Docket Number:	08-AFC-07C
Project Title:	GWF Tracy (Compliance)
TN #:	206391
Document Title:	Petition to Amend regarding Alternative Water Supplies
Description:	N/A
Filer:	Paul Kihm
Organization:	Latham & Watkins LLP
Submitter Role:	Applicant Representative
Submission Date:	10/19/2015 10:52:28 AM
Docketed Date:	10/19/2015

IN THE MATTER OF:) DOCKET NO. 08-AFC-07C
)
GWF TRACY COMBINED CYCLE POWER) PETITION TO AMEND REGARDING
PLANT) ALTERNATIVE WATER SUPPLIES
)
_____)

Route from Bogetti Farm to GWF Tracy Facility

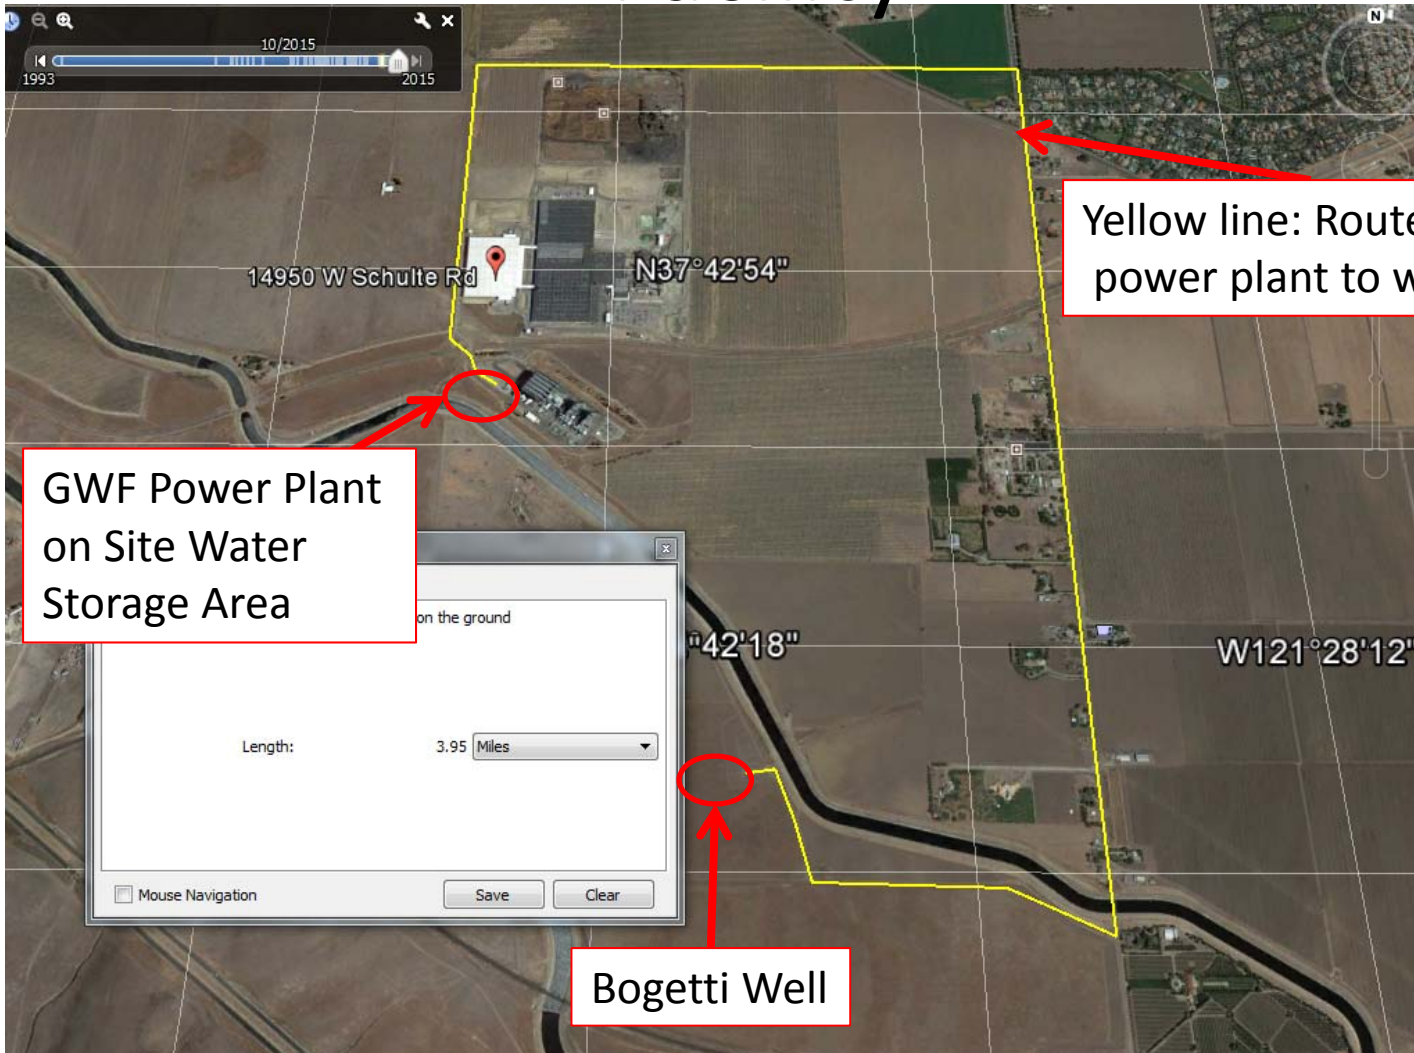
The proposed modification would allow transport of the Bogetti Water from the location of the well to GWF Tracy via truck. Transport of water would occur via 5,500 gallon capacity tanker trucks making 9-10 round trips per day. The distance between the Bogetti Water well and the GWF Tracy site is approximately 3.95 miles. The proposed truck route is shown in Exhibit A to this petition.

Placement of mobile storage trailers

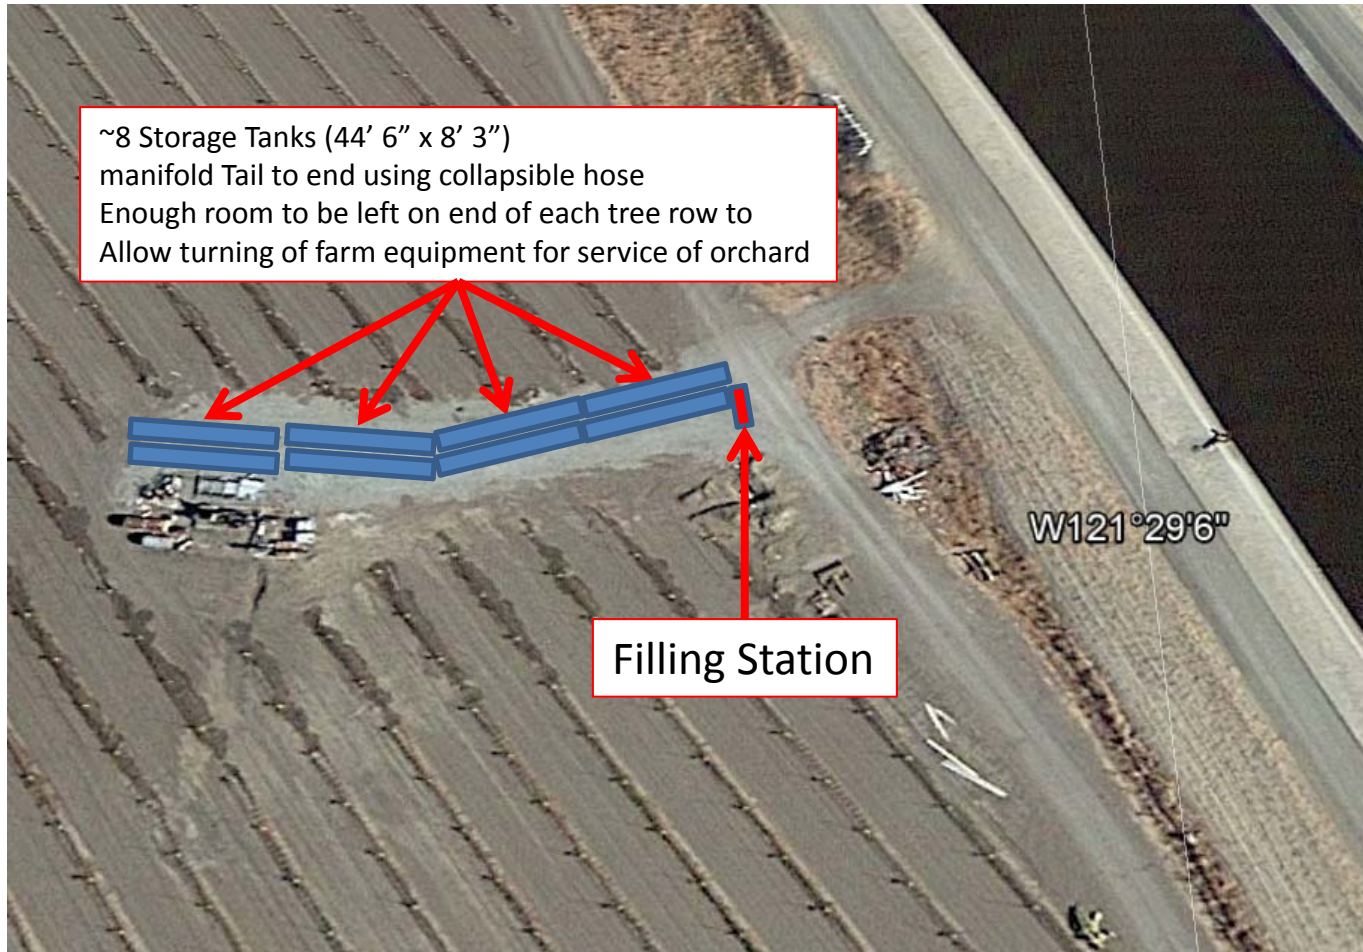
The alternative transportation method would require installation of eight temporary mobile storage tanks, with a capacity of 21,000 gallons each, at the location of the Bogetti Water well, and installation of one or more temporary storage tank(s) with a total capacity of 352,260 gallons at the GWF Tracy site. The temporary storage tank(s) at the GWF Tracy site would be equivalent to 15-20 of the 110 temporary storage tanks previously approved by the Commission. The proposed location of the well site storage and GWF Tracy site storage are shown in Exhibits B and C to this petition, respectively.

The temporary storage to be located at the site of the Bogetti Water well (Exhibit B) will be located on previously disturbed agricultural land. The alternative temporary storage to be located at the GWF Tracy site (Exhibit C) will be located on previously disturbed land within the fenceline of the site. Thus, the temporary storage tanks will not result in any significant environmental impacts.
